7 באוגוסט, 2019

הנדון: הערות המועצה המקומית זכרון יעקב לטיטות היתר הפליטה לאסדת הגז "לוויתן"

Leviathan Gas Platform **Emission Permit Review**

Figure 1. Cumulative distribution of annual NOx emissions for offshore platforms in the Gulf of Mexico.

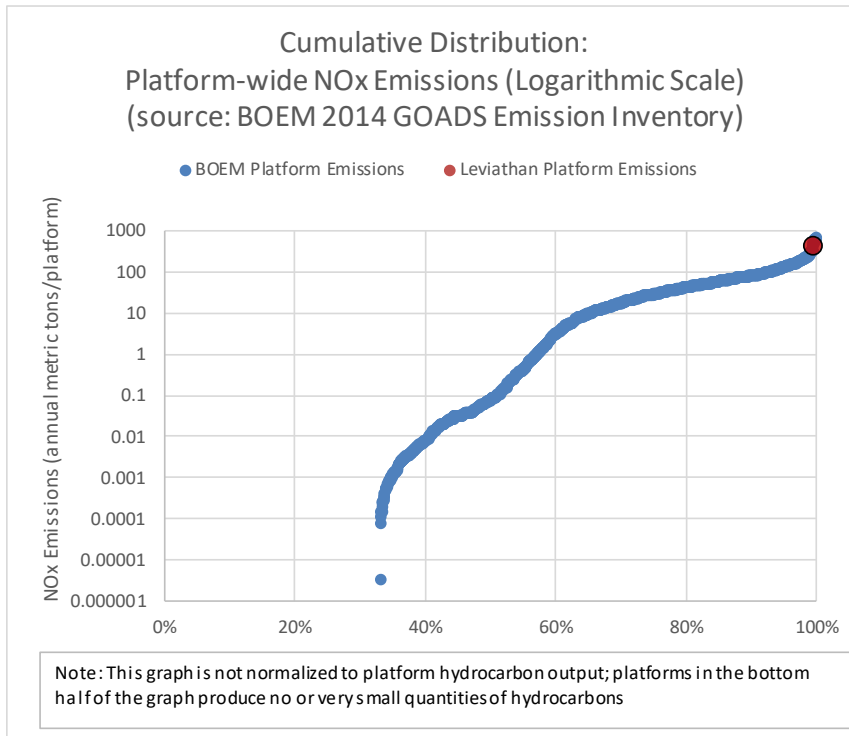
Figure 1 suggests that the Leviathan platform would be near the very highest percentile for NO_x emissions, similar to the less than 5% of the highest-emitting platforms in the Gulf of Mexico. By comparison, Figure 2 suggests that approximately 30% of platforms in the Gulf of Mexico would have higher VOC emissions than the Leviathan platform.
